Access Compliance Report

Public Rights-of-Way

(Curb Ramps)

Intersection ID: 49293	Main Street: ELIZABETH_CREST_LN	Cross Street: CHAMBERLIN_RD	Location: NE
ADA ID: A2BC4A0F3679	Ramp Type: BlendTrans1	Initial Pass/Fail: Pass	Overall Compliance: No
Severity Score: 0			
Codes/Mitigation Info/Possible Solution		Field Measurements/Component Compliance

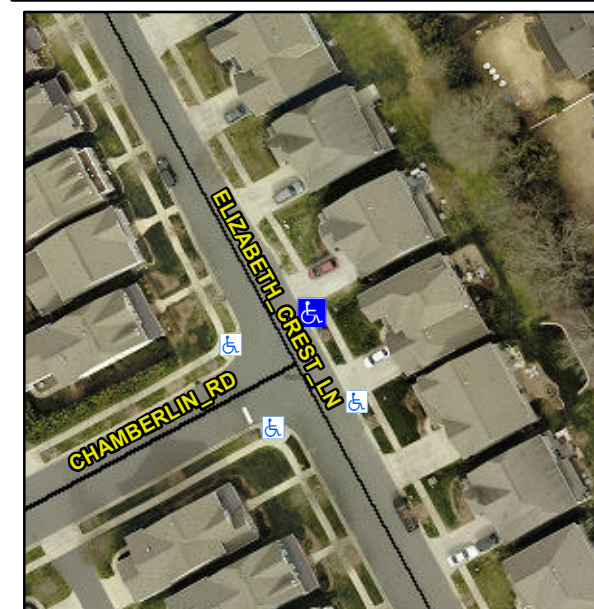
Not Found, R304.2.2-Perp, R304.3.2-Para, R305.2

Compliance	Description	Data	Compliance	Description	Data
N/A	Ramp Length (in)	72.0	Yes	BlendTrans Slope (%)	4.3
Yes	Ramp Width (in)	48.0	Yes	BlendTrans XSlope (%)	1.2
N/A	Flare Type LT	Sloped	N/A	Flare Type RT	Sloped
Yes	Flare Slope LT (%)	1.7	N/A	Flare Slope RT (%)	4.1
N/A	Flare Traversable LT?	Yes	N/A	Flare Traversable RT?	No
Yes	Landing Length (in)	48.0	Yes	DWS Provided?	Yes
Yes	Landing Width (in)	48.0	Yes	DWS Contrast?	Yes
No	Landing Slope (%)	4.3	Yes	DWS Length (in)	24.0
Yes	Landing X Slope (%)	1.2	Yes	DWS Full Width?	Yes
N/A	Landing Curb? (Y/N)	No	No	DWS Offset (in)	5.0
N/A	Shared Landing?	No			
Yes	Gutter Ponding?	No	Yes	Gutter Slope (%)	0.4
Yes	Gutter Lip Ht (in)	0.0	Yes	Gutter X Slope (%)	1.9
N/A	Painted X Walk1?	No	N/A	Painted X Walk2?	N/A
	X Walk 1 Direction	To SW		X Walk 2 Direction	N/A
	X Walk 1 Width (in)	N/A		X Walk 2 Width (in)	N/A
	X Walk 1 Slope (%)	1.2		X Walk 2 Slope (%)	N/A
	X Walk 1 X Slope (%)	1.7		X Walk 2 X Slope (%)	N/A

N/A	Ramp inside XWalk1?	N/A	N/A	Ramp inside XWalk2?	N/A
	Road Slope (%)	1.7		Clear Space?	Yes
	Road X Slope (%)	1.2	N/A	Clear Space to XWalk (in)	N/A
Yes	Any Obstructions?	No	Yes	Storm Grate/Utility Hazard?	No
	Obstruction Type			Storm Grate/Utility Type	
		N/A			N/A
			Yes	Surface Condition? (G/P)	Good
			No	Curb Slope (%)	6.4

Remove & Replace Curb Ramp With Two New Directional Ramps or Equivalent.
